**GULF STATES UTILITIES COMPANY**

February 6, 1985  
RBG- 20,086  
File No. G9.5, G9.23,  
G9.8.6.2

River Bend Station - Unit 1  
Docket No. 50-458

Enclosed are revisions to the River Bend Station Final Safety Analysis Report for your information. Attachment 2 supplements and/or revises my letter of November 29, 1984 (RBG-19,576) on this subject. These revisions support previous discussions with your staff and will be appropriately included in a future FSAR amendment.

FSAR Figure 7.3-11 Sheets 3, 5, 6, 8, 9 & 11

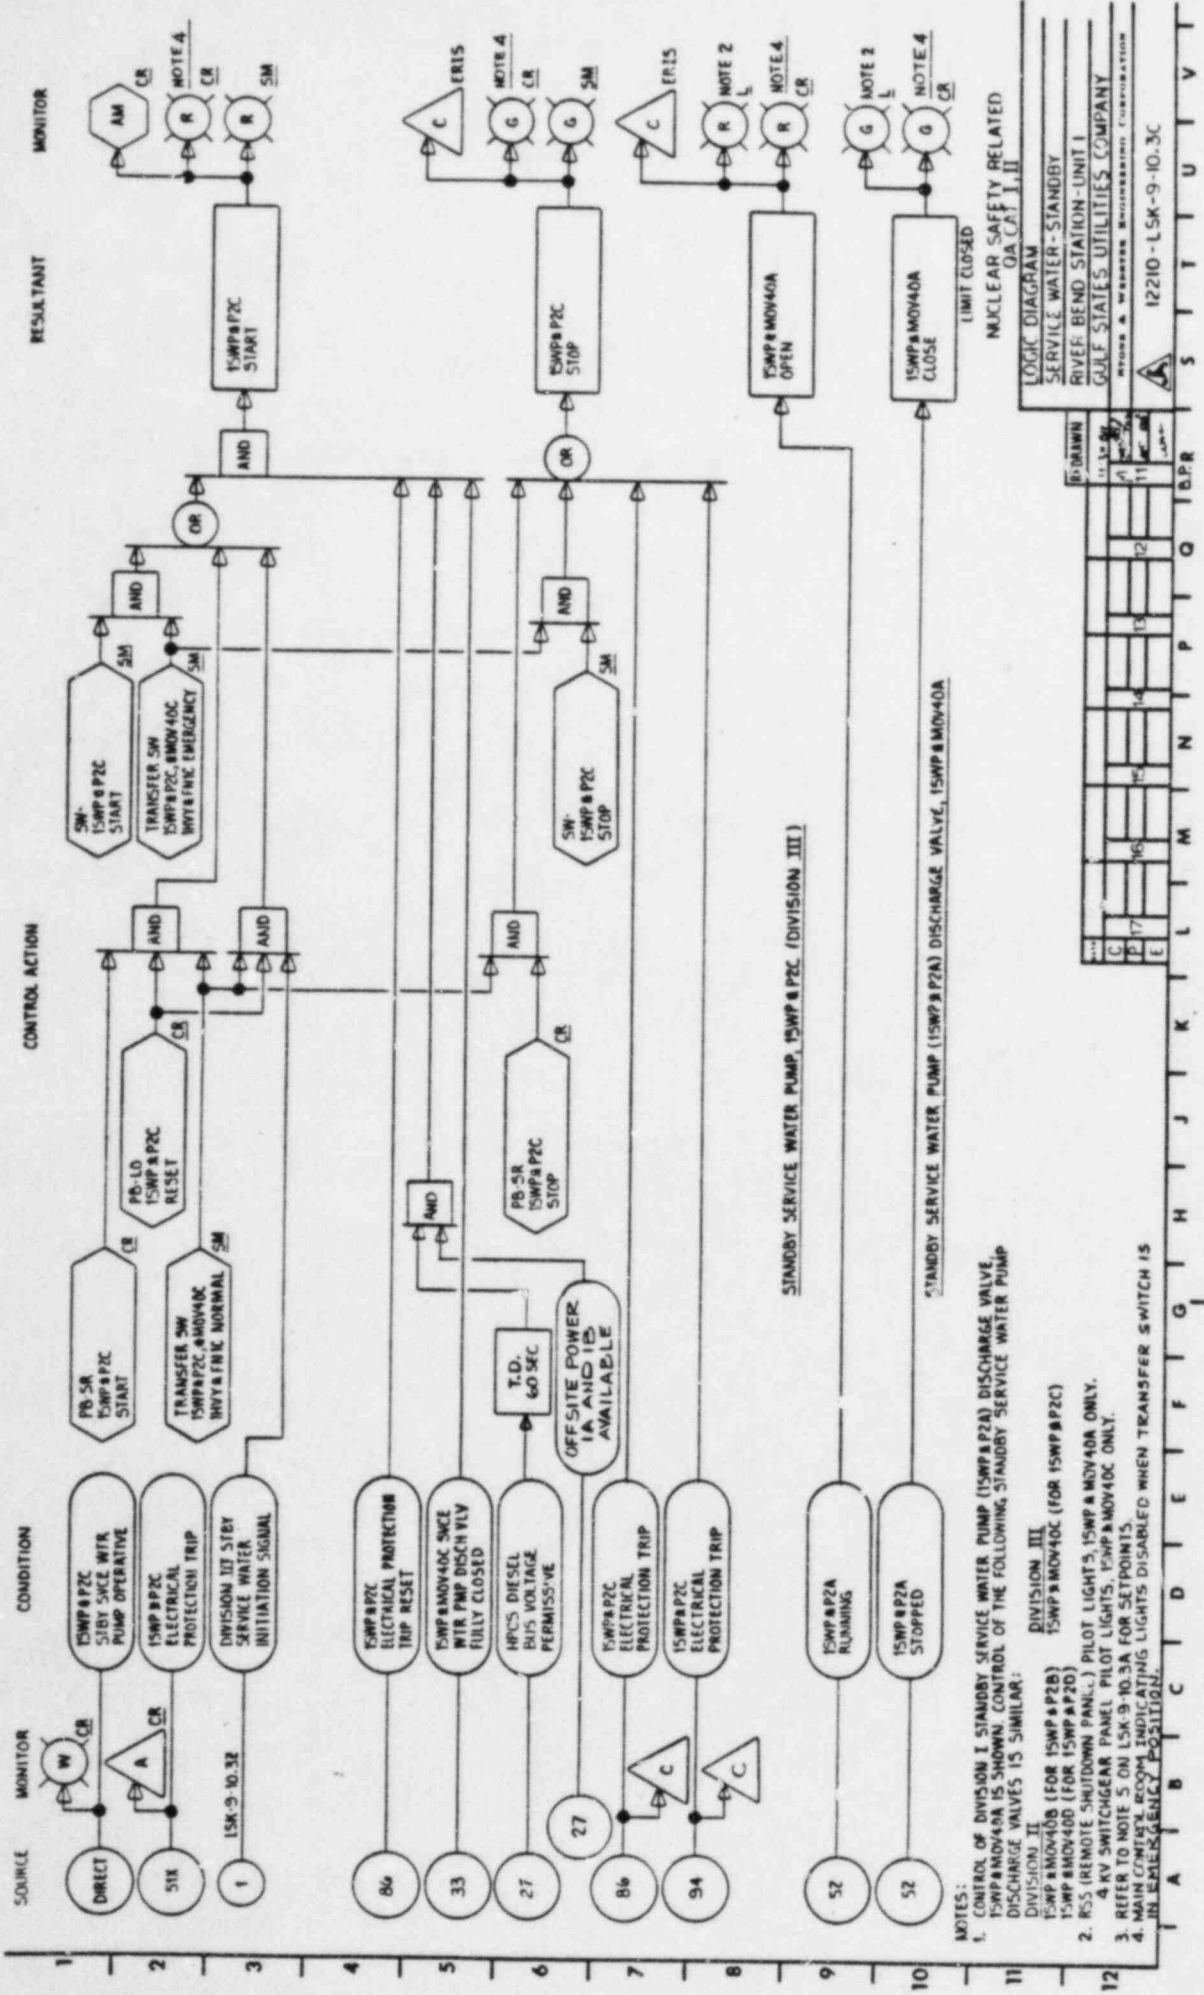
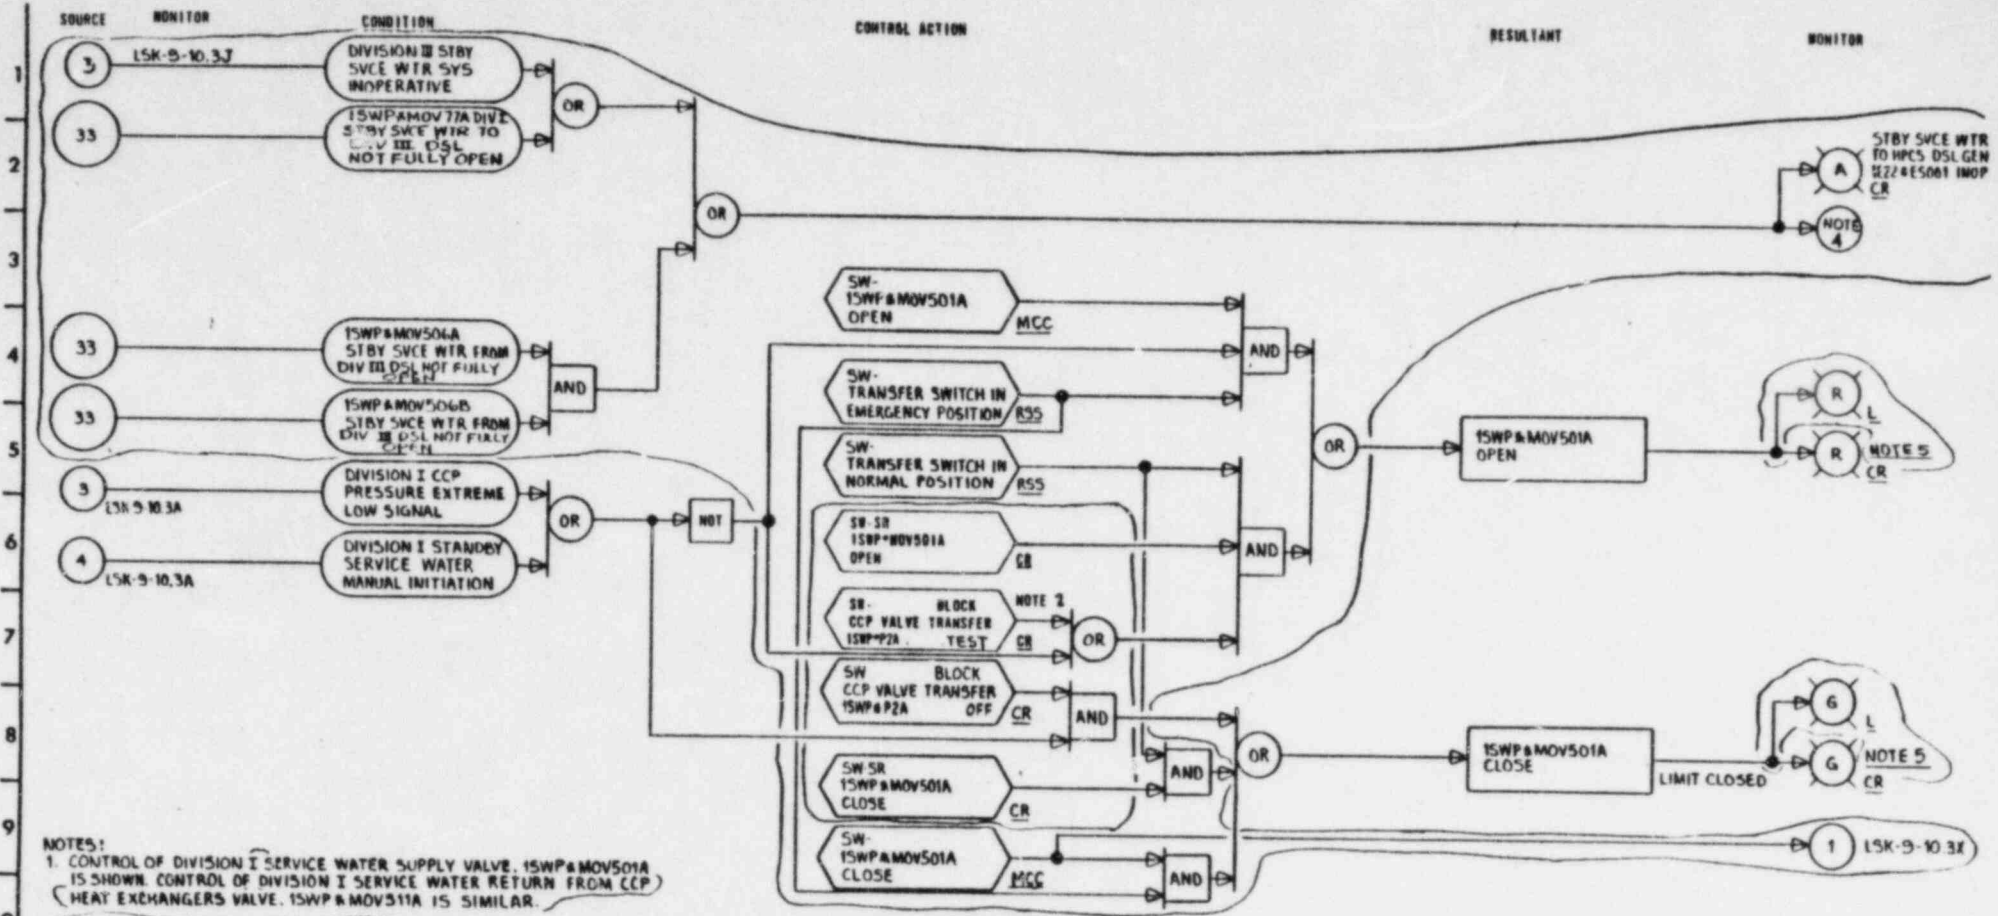
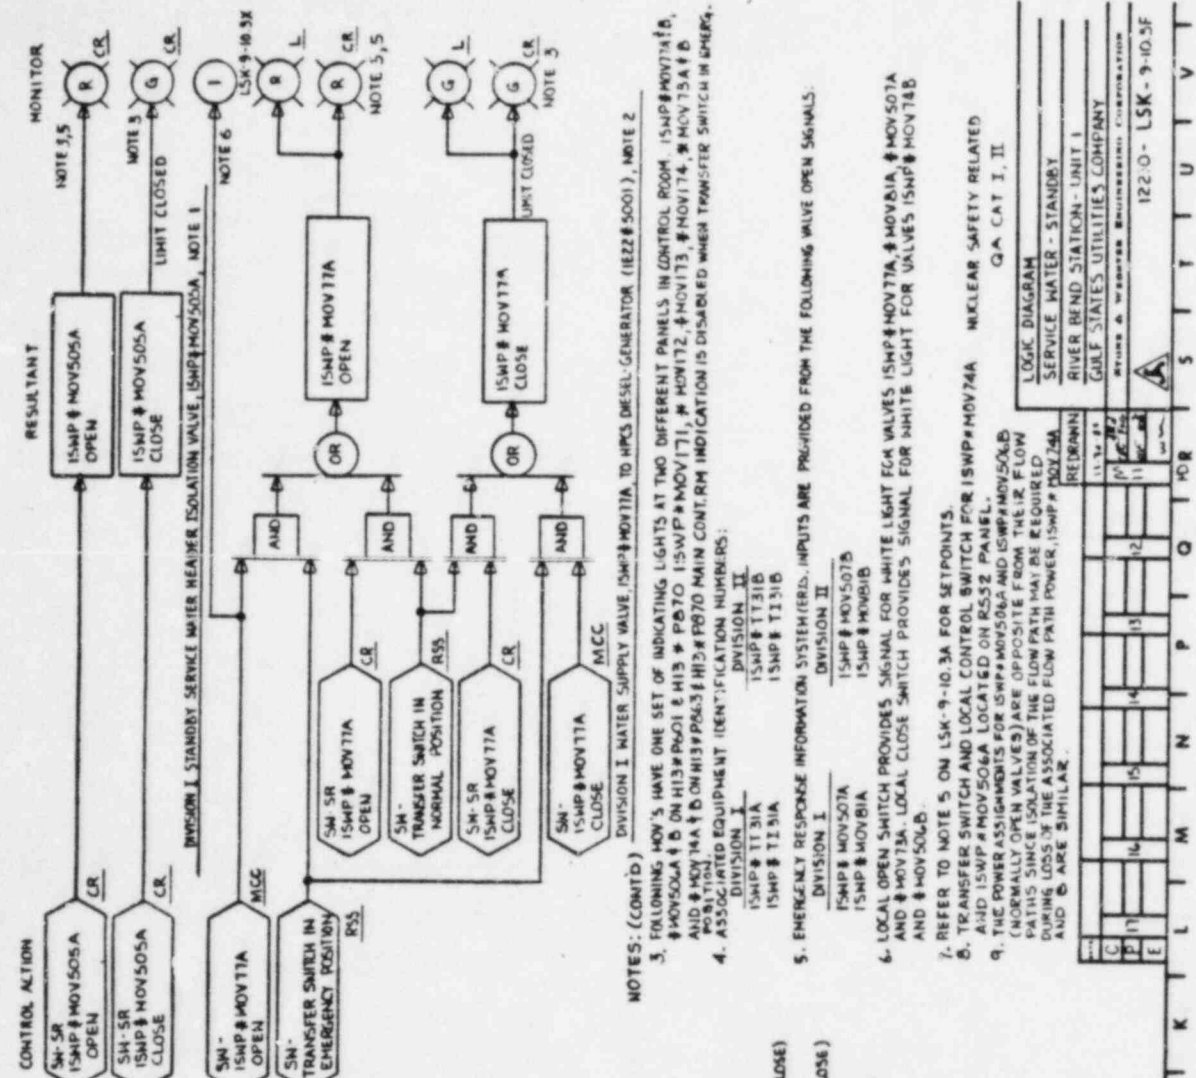
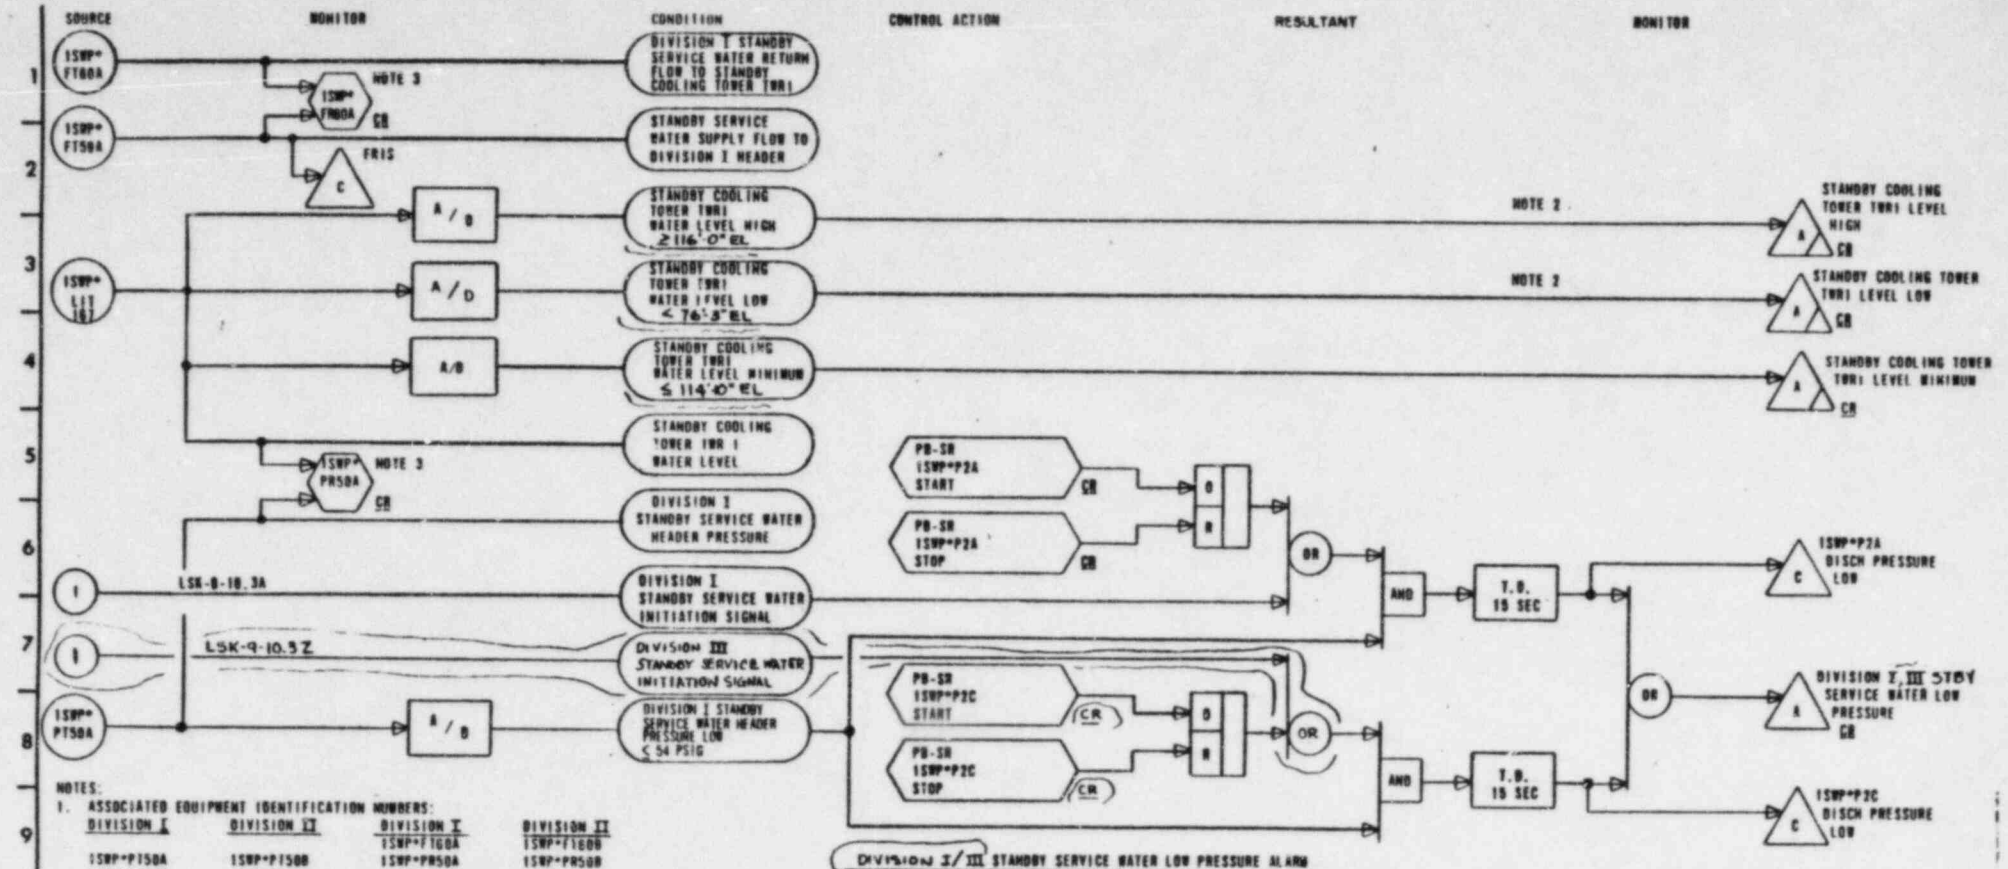
will be updated to reflect the attached LSK's.
